SUBJECT: NuScale Power, LLC Response to NRC Request for Additional Information No. 332 (eRAI No. 9245) on the NuScale Design Certification Application

NuScale Response to NRC Request for Additional Information eRAI No. 9245

eRAI No.: 9245

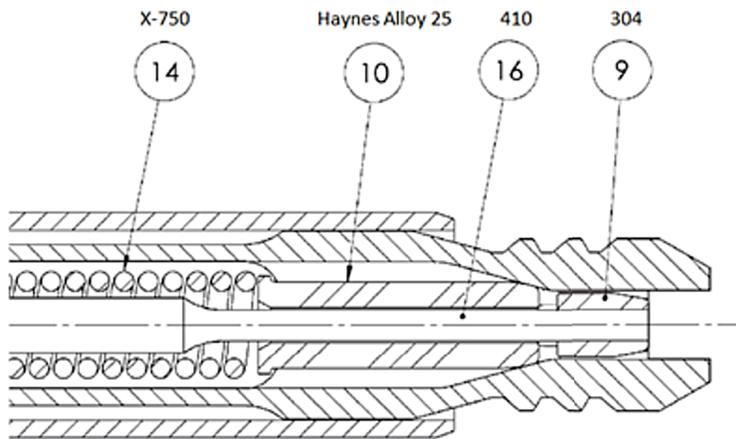
The design documents reviewed by the NRC staff during the CRDM Audit, indicated that due to the length of the control rod drive shaft and the expected deceleration forces expected during control rod dropping, that there was a potential for increased flexure at the control rod drive shaft to control rod assembly junction. The applicant stated that the design of the CRDMs was not complete, so future design work and testing of this junction was expected. Since the applicant is currently unable to provide additional information regarding how increased flexure of this junction could affect cobalt introduction rates, the staff was not able to identify how the expected extra wear at this junction was factored into estimating the introduction of cobalt-

Since the applicant is currently unable to provide additional information regarding how increased flexure of this junction could affect cobalt introduction rates, and because cobalt is a major source of radiation exposure in operating nuclear power plants, increased wear of cobalt containing material will increase operational radiation exposure, contrary to the requirements of 10 CFR 20.1101(b) and fails to minimize contamination in accordance with 10 CFR 20.1406.

1. Explain/justify the amount of allowable flexure for the control rod drive shaft, including the limiting number of cycles, the basis for the stated flexure value, and the expected material wear rates,
2. Explain/justify the testing that will be performed to assess the actual amount of control rod

drive shaft flexure,

3. As necessary, revise and update section 12.3 of the NuScale DCD to specify the design features of the control rod drive shaft provided to minimize the introduction of cobalt due to flexure,

Figure 2-17, in TR-0716-50439, shows the configuration of the control rod guide tubes. The CRA cards have a clearance hole that is currently 1/8 inch larger than the diameter of the control rod drive shaft, and limits the displacement at these locations to a maximum of 1/8 inch. The support from these CRA cards was not included in the buckling analysis to make it a very conservative analysis.

The Cobalt item, at the base of the control rod drive shaft, is the coupling expansion plug, item 10, in the figure below. The design of this latching interface is similar in form and in material to the control rod latching mechanisms in service in the existing fleet. In these existing applications Haynes Alloy 25 has proved to be the appropriate material for these applications. Since this item is inside the control rod drive shaft there will be very little motion due to any shaft bending (flexure) motion during a SCRAM. The vertical motion is also expected to be similar to that of similar mechanisms in the existing fleet, verification of this is one of the items that will be evaluated in the qualification testing. The wear characteristics will also be evaluated to see if an alternate material can be used, however industry experience has shown that Haynes Alloy 25 is the appropriate material for this application.
